WATTS BAR NUCLEAR PLANT (WBN) UNIT 1 - RESPONSE TO REQUEST FOR
ADDITIONAL INFORMATION REGARDING REQUEST FOR LICENSE AMENDMENT TO
TECHNICAL SPECIFICATIONS (TS-WBN-96-010) - SPENT FUEL POOL STORAGE
CAPACITY INCREASE (TAC NO. M96930)

WATTS BAR NUCLEAR PLANT (WBN) UNIT 1
REQUEST FOR ADDITIONAL INFORMATION
SPENT FUEL STORAGE CAPACITY

FIGURE 1

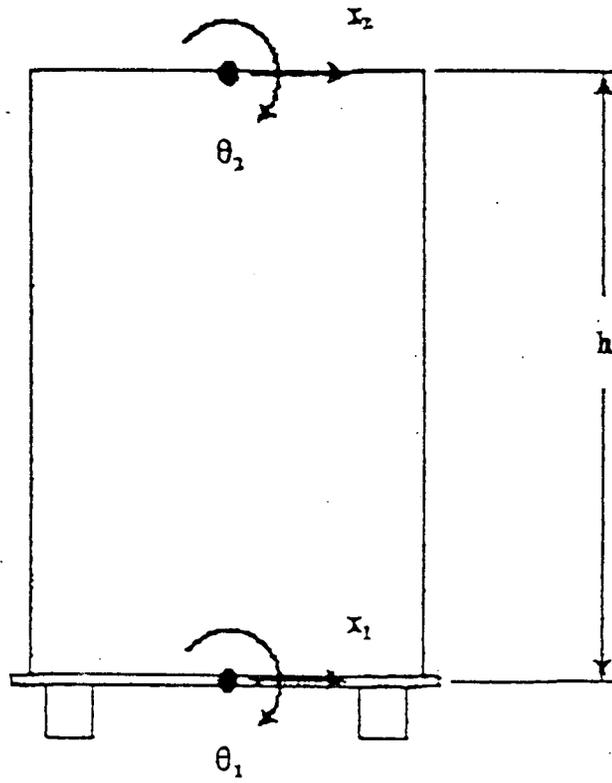
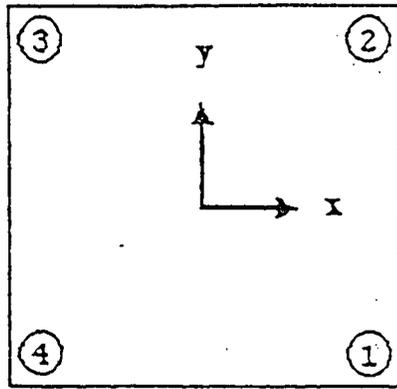
Provide a complete deformation shape for the rack from the bottom to the top for the single rack SSE analysis when the maximum displacement at the rack top corner equals 0.704 inch.

The maximum rack top corner displacement obtained from single rack analysis under SSE conditions is -0.704 inches. This displacement is in the local x-direction and occurs at 24.97 seconds. At any instant in time, the displacement of the rack is fully described by its 12 rack DOF. Inspection of the DOF values at the time of maximum top corner displacement reveals that the dominant rack motion is rigid body motion. A combination of rigid body translation in the x-direction and rigid body rotation about the y-axis accounts for 91.6% of the maximum rack top corner displacement. Figure 1 (attached) identifies the significant DOF at the time of maximum corner displacement. The values of these DOF are:

where h equals the height of the cells above the baseplate (h = 164.5 in). Substituting the values for x_1 and Θ_1 above, x_{top} equals -0.645 inch. The remaining -0.059 inch of the maximum corner displacement is due to beam-type bending of the rack cells, torsion of the rack cells and rigid body rotation about the vertical z-axis. The sum total of these three components accounts for only 8.4% of the total displacement.

To confirm this rigid body motion, the calculated forces in the rack pedestal springs are checked at the time of maximum corner displacement. For identification, the pedestals are numbered 1 through 4 in Figure 1. The calculated forces in the pedestals are:

As expected, two pedestals lose contact with the pool liner as the rack tilts in the negative x-direction. This indicates the rack behaves as a rigid body.

FIGURE 2

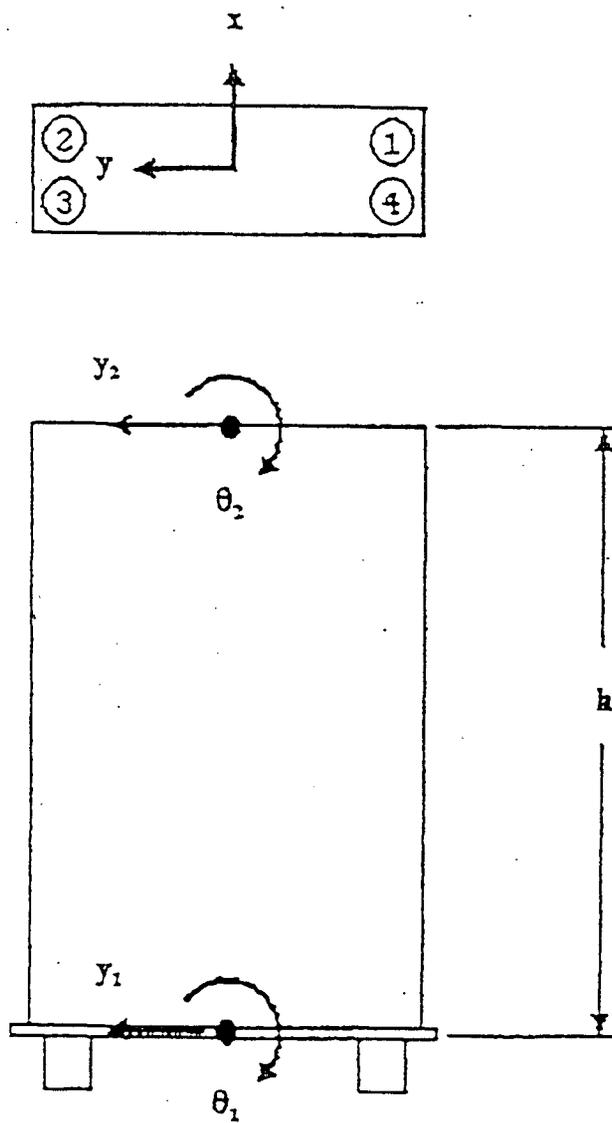
Provide a complete deformation shape of the rack for the multi-rack SSE analysis when the maximum displacement at the rack top corner equals 1.394 inches.

where h equals the height of the cells above the baseplate (h = 164.5 in). Substituting the values for y_1 and Θ_1 above, y_{top} equals 1.372 inches. The remaining 0.022 inch of the maximum corner displacement is due to beam-type bending of the rack cells, torsion of the rack cells, and rigid body rotation about the vertical z-axis. The sum total of these three components accounts for only 1.6% of the total displacement.

To confirm this rigid body motion, the calculated forces in the rack pedestal springs are checked at the time of maximum corner displacement. For identification, the pedestals are numbered 1 through 4 in the attached Figure 2. The calculated forces in the pedestals are:

As expected, two pedestals lose contact with the pool liner as the rack tilts in the positive y-direction. This indicates the rack behaves as a rigid body.

Figure 3

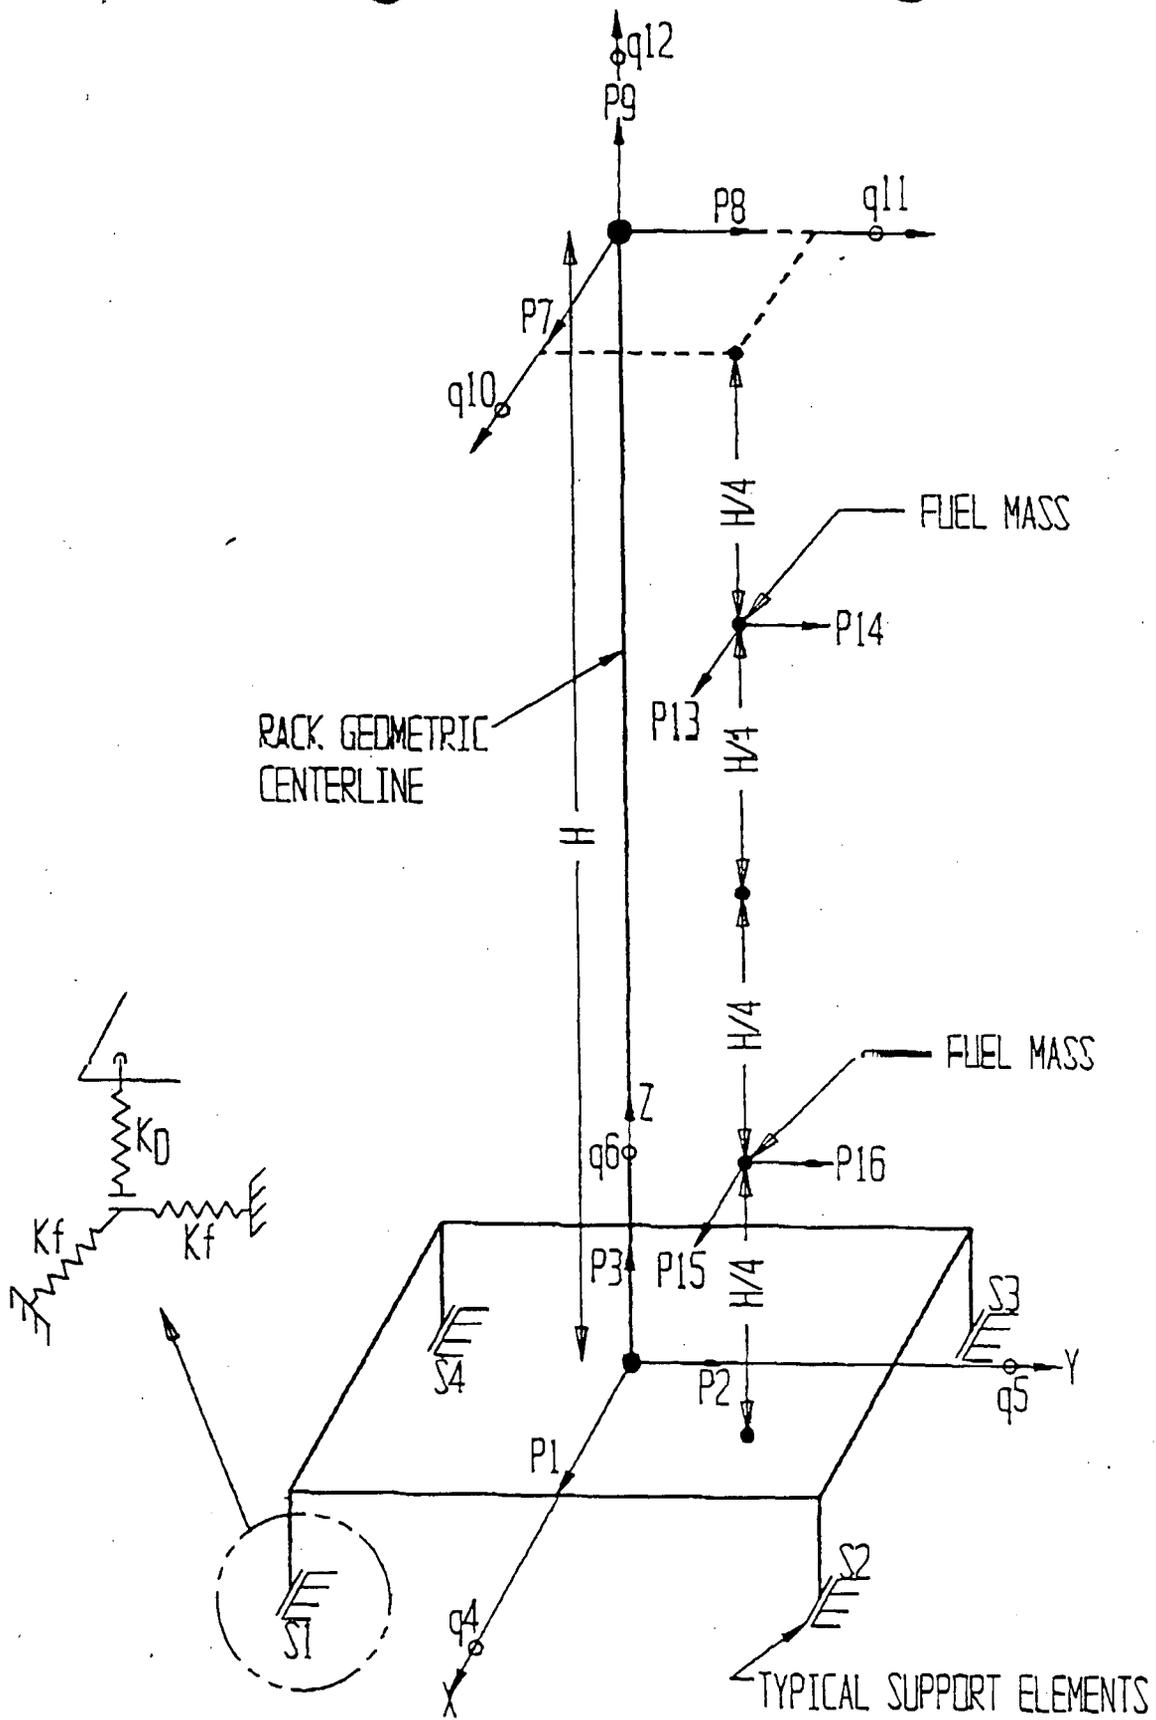
d) Describe how your program, DYNARACK, handles the leg separation (lift-off) and calculates the leg impact forces.

Each rack in the pool is modeled as a mass/spring system with 16 degrees of freedom (see Figure 3 attached). As discussed in section 6.5.7 of the October 23, 1996, licensing submittal, the computer code DYNARACK uses a central difference scheme to solve the equations of motion for each degree of freedom. This numerical method, as it pertains to the rack pedestals, can be described as follows. The displacement of each degree of freedom is calculated for a small time step (e. g., 0.0001 sec). The extension, δ , of any pedestal can be expressed in terms of the current values of P3, Q4, and Q5 in Figure 3. Based on these incremental displacements, the force on each pedestal spring is determined from the equation $F = -k\delta$. If the force, F , is tensile, then F is automatically set equal to zero. These pedestal forces are used in the next time step to compute new displacements. This calculation scheme is repeated until the final time is reached.

A pedestal is separated from the liner at all time steps where the spring is extended (i. e., δ is positive). Pedestals are in contact at time steps where the extension of the spring, δ , has a negative value. The compression force at any time during contact is proportional to the magnitude of δ .

Figure 4

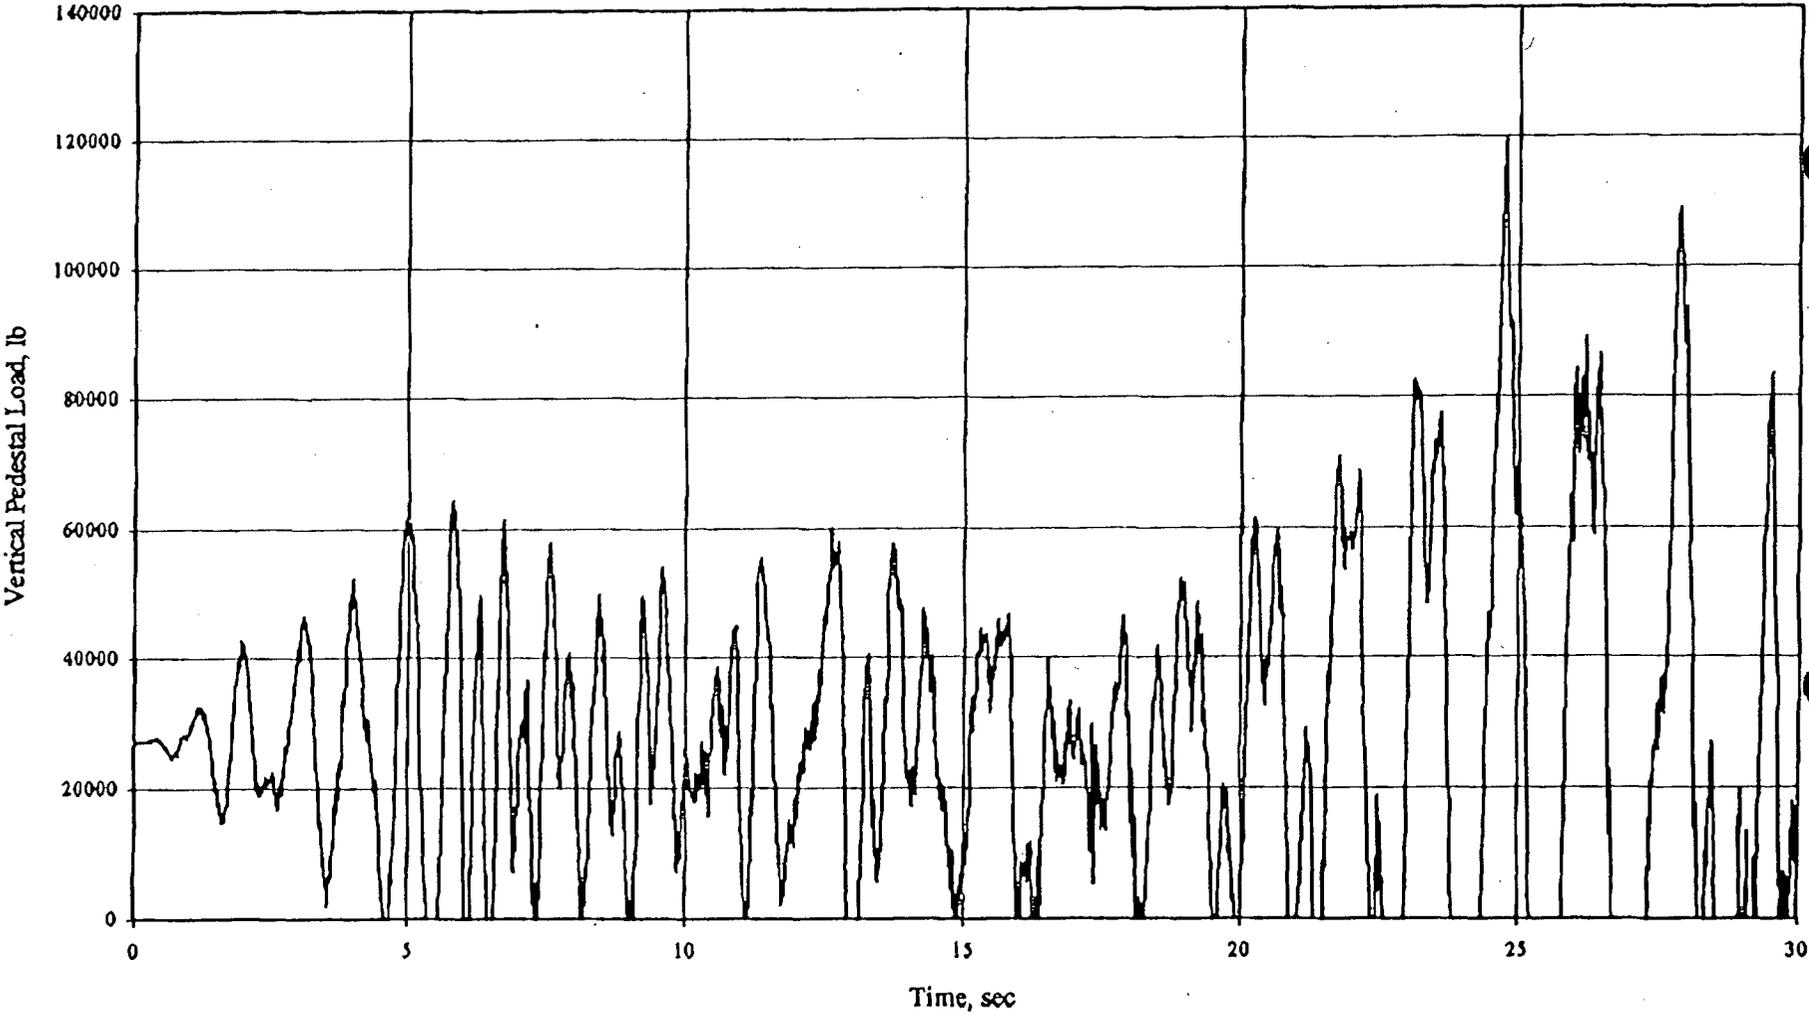
- g) Provide a figure that shows complete and negative vertical pedestal loads for the worst case.

Figure 4 attached shows the complete time history plot of vertical pedestal load for the worst case.
